# Mercer Island Transit Interchange

Responses to Mercer Island Councilmember Comments and Requests for Additional Information

I. Additional Interchange Study Info Requests from KC Metro, forwarded by Kirsten Taylor (City of Mercer Island) via email on February 19, 2019

# TYPICAL BUS MOVEMENTS THROUGH PROPOSED TRANSIT INTERCHANGE

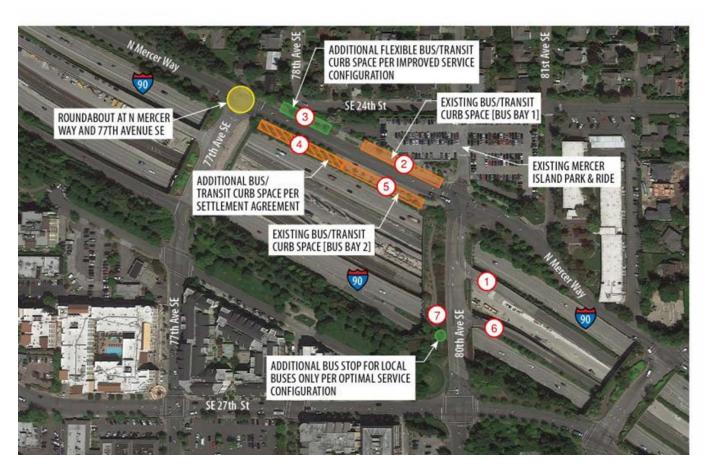
1. Describe normal operations for buses moving through the bus/rail interchange.

- A. Re the proposed 80th Ave. location for pick up and drop off.
  - 1. Is it both pick up and drop off, or just drop off?

<u>Response</u>: For buses traveling off the island, the general expectation is that buses traveling westbound on I-90 will drop off passengers on the north side of N. Mercer Way, utilize the layover spaces on the north or south sides of N. Mercer Way for operator rest periods and scheduling maintenance, and then pick-up passenger on the south side of N. Mercer Way before accessing the eastbound I-90 ramp on 80<sup>th</sup> Avenue SE. See "TYPICAL BUS MOVEMENTS THROUGH PROPOSED TRANSIT INTERCHANGE" figure attached.

<u>Response</u>: The previously anticipated 80<sup>th</sup> Avenue SE bus stop would have been used primarily to pick up passengers. However, recent transportation agency (ST, KCM, WSDOT, and City of Mercer Island Engineering) discussions have resulted in a changed to this proposed bus stop; this bus stop will now be reserved for local Mercer Island buses only and would be located inlane and south of the I-90 EB HOV on-ramp.

- 1. Regional buses from Eastside origins exit I-90 WB via HOV off-ramp.
- 2. Regional buses drop-off passengers at bus stop on north side of N Mercer Way.

- 3. Regional buses move to this layover/flex space depending on schedule and/or layover requirements, then pick-up passengers at 5 via roundabout.
- 4. Regional buses move to this layover/flex space via roundabout depending on schedule and/or layover requirements, then pick-up passengers at 5.

- 5. Regional buses pick-up passengers from points 2, 3, <u>OR</u> 4 (all regional buses use roundabout to reverse direction on N. Mercer Way). <u>Bus movement options</u>: a) 2 then directly to 5; b) 2 then 3 for <u>layover then 5</u>; or 2 then 4 for <u>layover then 5</u>.

- 6. Regional buses return to Eastside destinations via I-90 EB HOV on-ramp.
- 7. Pick-up and drop-off for local Mercer Island buses only to Town Center and other Mercer Island destinations.
